ATTACHMENT 2

NRC DOCKET 50-321
OPERATING LICENSE DPR-57
EDWIN I. HATCH NUCLEAR PLANT UNIT 1
PROPOSED CHANGES TO TECHNICAL SPECIFICATIONS

Figure 3.11-1 (Sheet 3)

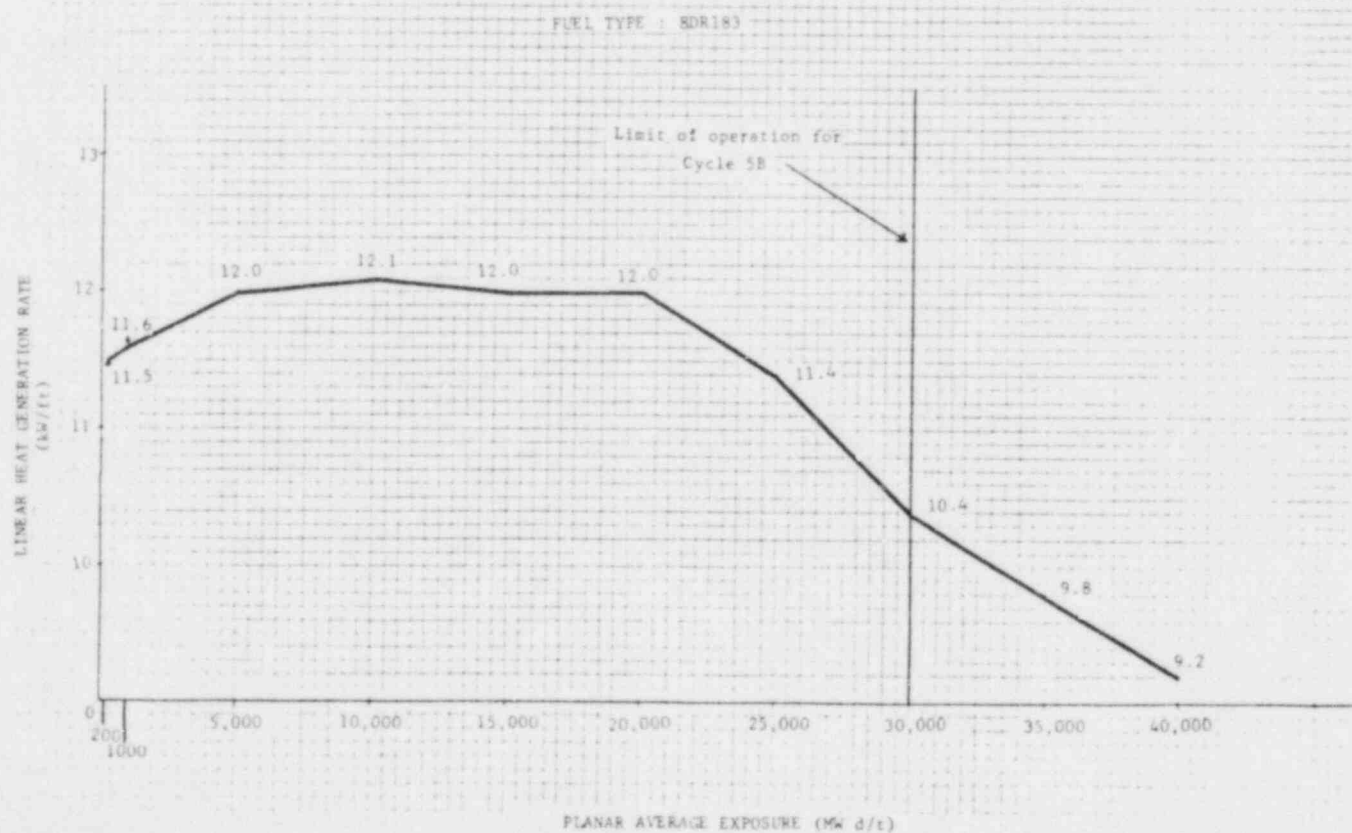
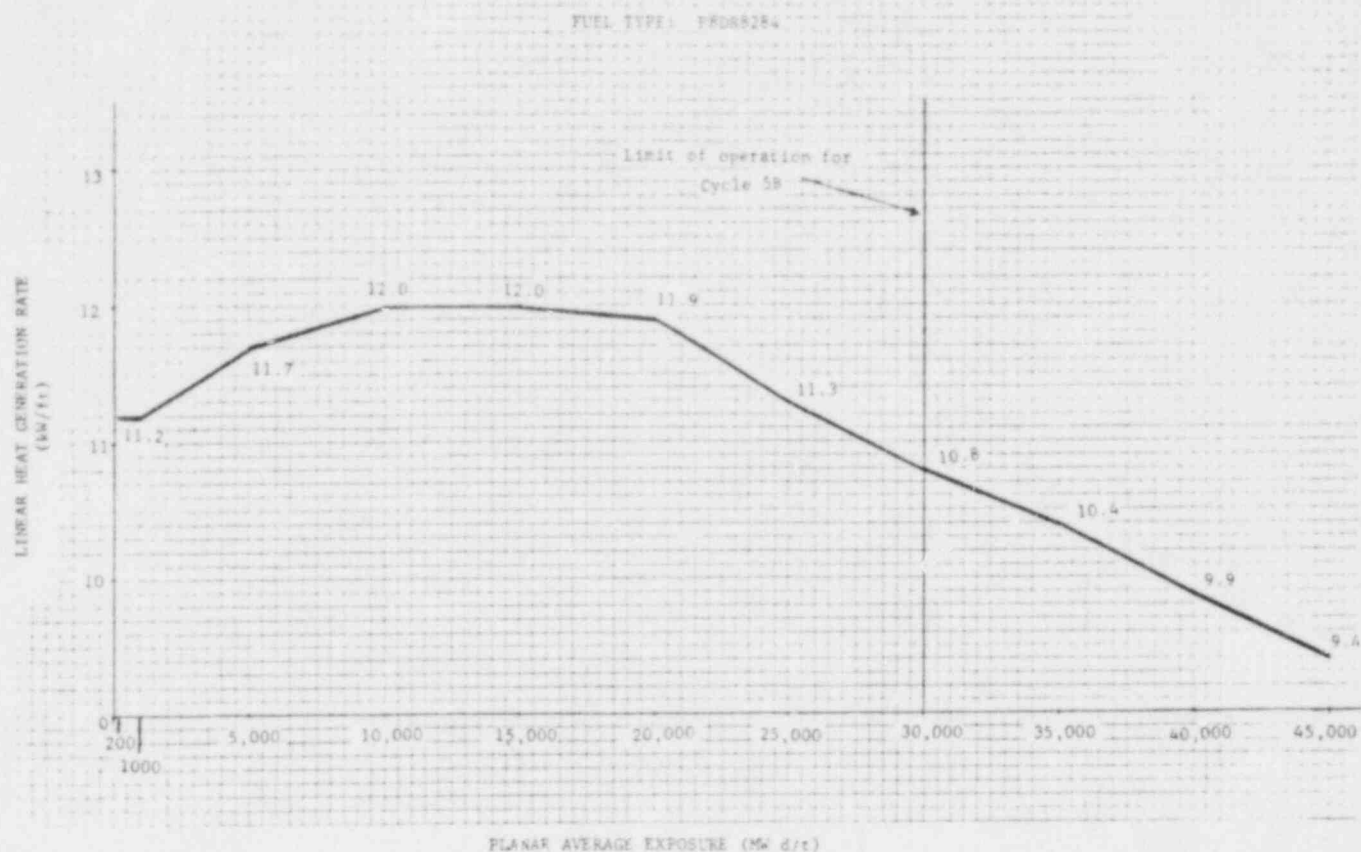
During power operation, the APLHGR for each type of fuel as a function of average planar exposure shall not exceed the limiting value shown in Figure 3.11-1, sheets 1, 2 and 3. If at any time during operation it is determined by normal surveillance that the limiting value for APLHGR is being exceeded, action shall be initiated within 15 minutes to restore operation to within the prescribed limits. If the APLHGR is not returned to within the prescribed limits within two (2) hours, then reduce reactor power to less than 25% of rated thermal power within the next four (4) hours. If the limiting condition for operation is restored prior to expiration of the specified time interval, then further progression to less than 25% of rated thermal power is not required.

MCPR LIMIT FOR P8X8R FUEL

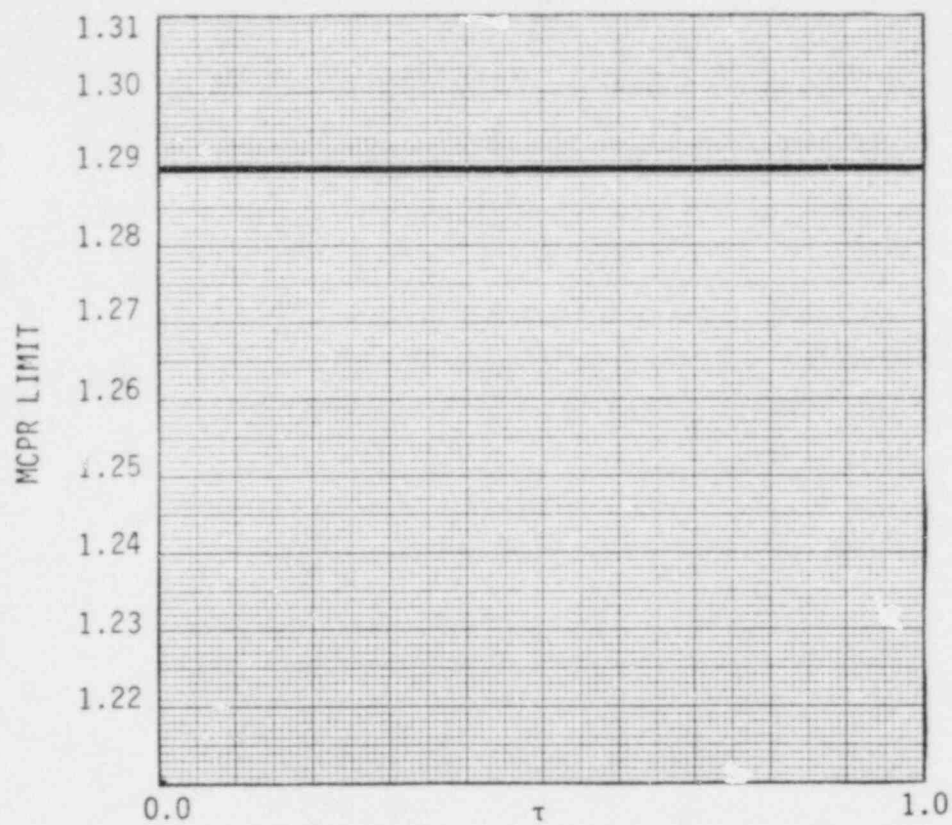
- a) The proposed amendment does not require the evaluation of a new Safety Analysis Report or rewrite of the facility license;
- b) The proposed amendment does not contain several complex issues, does not involve ACRS review, and does not require an environmental impact statement;
- c) The proposed amendment does not involve a complex issue, an environmental issue or more than one safety issue;
- d) The proposed amendment consists of two changes, each involving, a single safety issue, namely, addition of MAPLHGR operating limits for two new fuel types, and an increase in the Rod Block Monitor setpoint and MCPR limit as a result of new analyses.
- e) The proposed change is therefore two Class III amendments.
